RE: MAJOR PROJECT (MP07_0086) REDLAKE ENTERPRISES TOMAGO

We refer to the submissions received in response to the public consultation process as previously responded to, letter from the RTA dated 23 June 2008 and facsimile from the Department of Planning dated 29 August 2008 and provide the following consolidated response.

Project: Tomago Industrial Development
Subject: Site access design note – review of traffic generation rates
Date: September 11, 2008
Ref: P0168

Noise Impact Assessment WesTrac Facility and Industrial Subdivision Tomago, NSW

Figure 5. Location of recommended acoustic barrier.

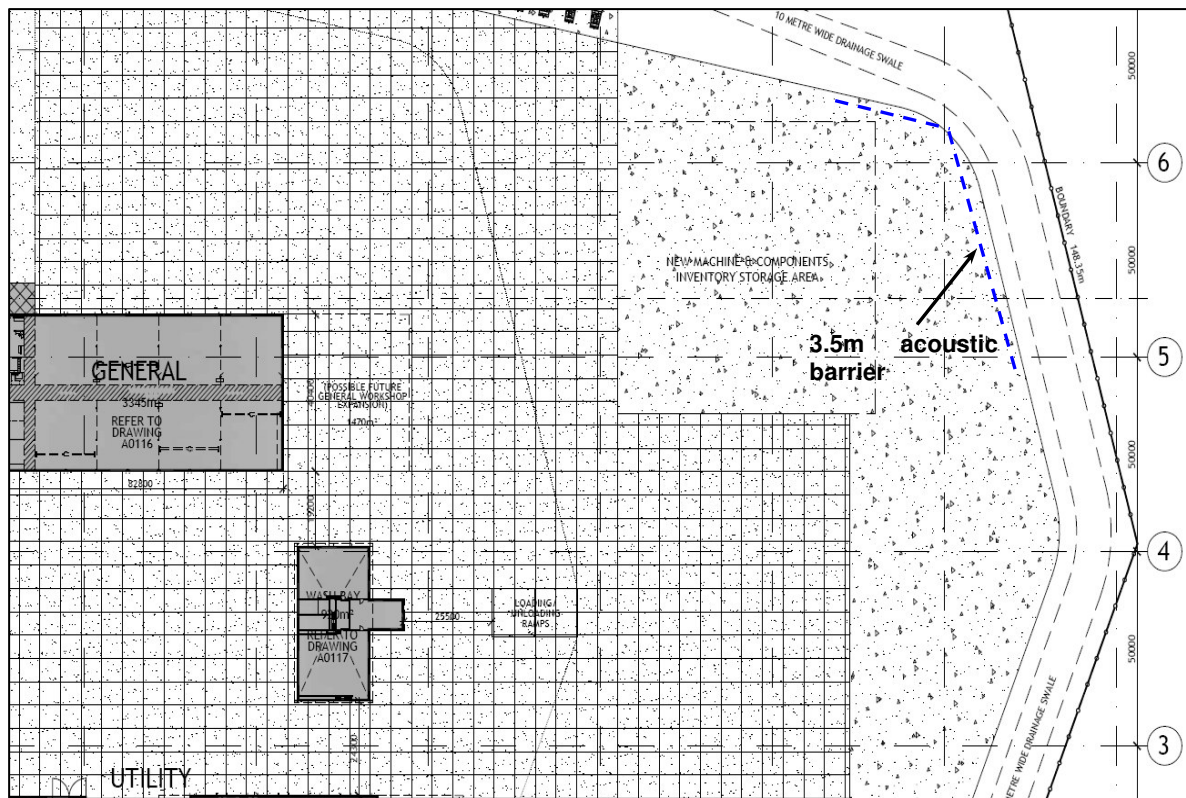
If the Proponent wishes to be able to move parts around in the inventory area during the evening or at night, it is recommended that a 3.5m high acoustic barrier be erected along a portion of the eastern site boundary to provide 7dB attenuation to 175 Tomago Road. The recommended location and minimum extent of the acoustic barrier is shown in **Figure 5**.

Noise levels were re-calculated using ENM with the 3.5m barrier in place as shown in Figure 5. Predicted noise levels are summarised in **Table 7**. Noise contours showing the effect of the acoustic barrier under inversion conditions are shown in **Figure B2** in Appendix B.

The calculation results in Table 7 suggest that the proposed 3.5m acoustic barrier will provide sufficient attenuation of noise from the outside inventory area to satisfy the night-time operational noise criterion.

FIGURE B1

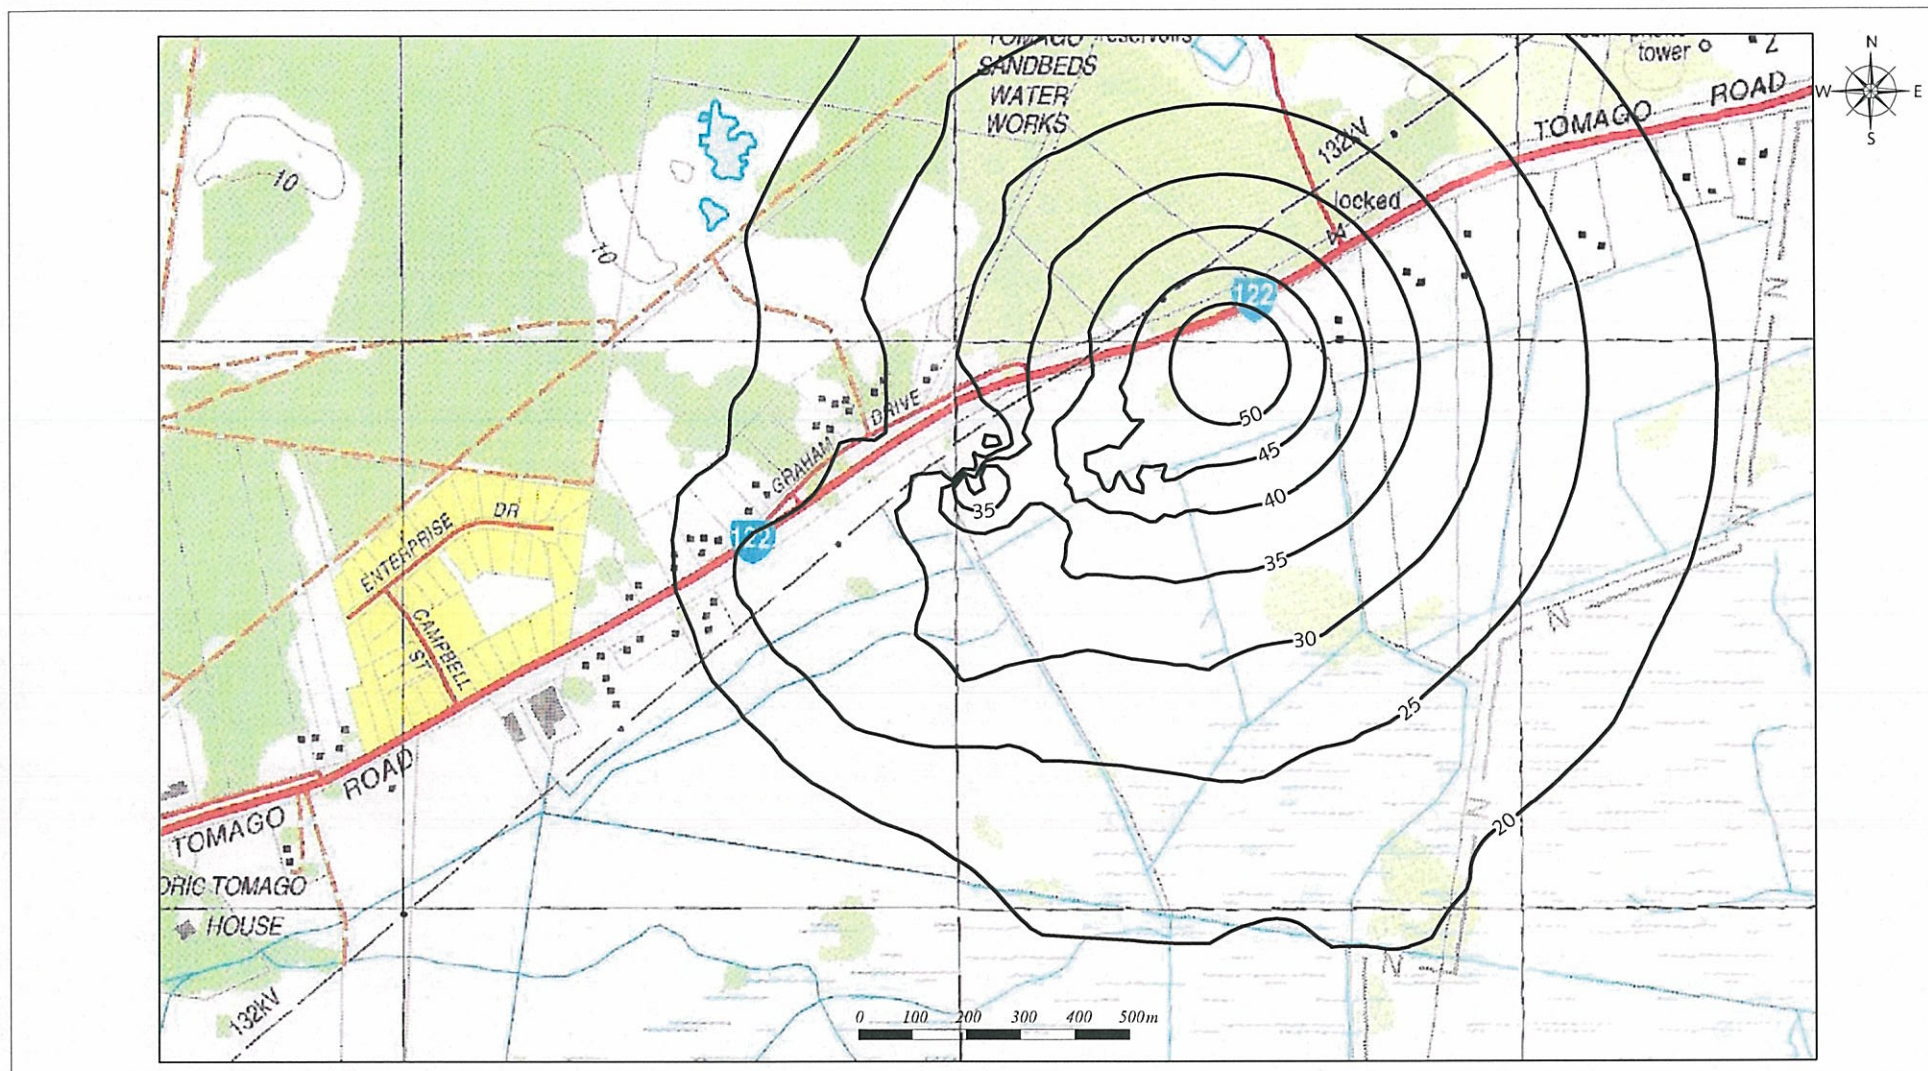
Noise contours prepared for the Westrac Facility (Appendix B of acoustic assessment) show noise levels of approximately 20 dB(A), L_{eq} at the nearest point of the wetland area (with no acoustic barrier and under inversion conditions). Maximum impact levels of up to 32 dB(A) are also likely at this distance. A level of 20 dB(A) is at least 10 dB below the existing background noise level and the predicted maximum level of 32 dB(A) is comparable with the background level. Such low levels of noise are not likely to disturb or even be noticed by wetland birds (see information below).

The noise contours also show noise levels of approximately 47 dB(A), L_{eq} at the southern boundary of the Westrac site (with no acoustic barrier and under inversion conditions). Maximum impact levels of up to 59 dB(A) are also likely at this distance. These levels will be adopted as indicative levels that may be experienced by migratory birds close to the southern-most industrial development in the south-east corner of the project site. Reference to the project site layout in relation to the wetland area shows that the site boundary slopes towards the northwest from the southeast corner and the distance to the nearest point of the wetland increases to a distance of over 1 km, thereby greatly reducing potential noise impacts.
